SUNNYSIDE COGENERATION ASSOCIATES

**RE: Project No. EC450593: Sunnyside Cogeneration Associates
Permit Submittal NOV N94-26-4-1 100 year 6 hour Diversion down Refuse Pile**

Title of Change: **SUNNYSIDE COGENERATION ASSOCIATES**
Redesign of RC-D6 to install 36" Culverts RC-C1, RC-C2, & RC-C3
Associated with NOV N94-26-4-1

TYPICAL DRAWING FOR INSTALLING OF 36" CULVERTS
RC-C1,RC-C2,RC-C3 AND ENERGY DISSIPATOR/SPLASH POOLS

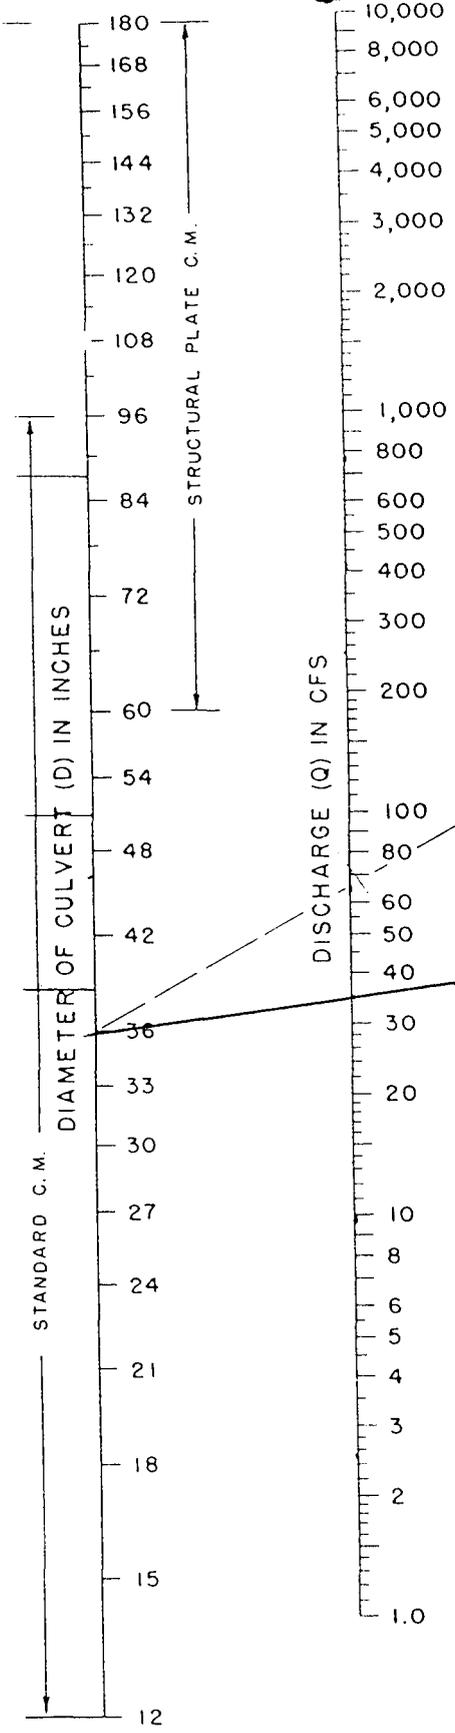
This submittal includes a typical design for the diversion down the existing refuse pile in connection with step one of NOV N94-26-4-1. This diversion was identified as RC-D6 on Plate 7-1D.

This diversion has been re-designed to use a series of 36" culverts (RC-C1, RC-C2, and RC-C3) to convey the storm runoff from the 100 year 6 hour storm. At each terrace, an energy dissipating splash pool will be constructed to slow down the velocity, incorporate the additional runoff water from the terrace, and drop some sediment from the runoff. The 36" culvert diversion is clearly over designed for the current conditions under the regulations, but the permittee wishes to minimize the risk of future flood damage in this area by planning for greater potential flows.

The typical drawing should provide an idea of the diversion intended. Actual construction will be adapted to meet conditions in the field.
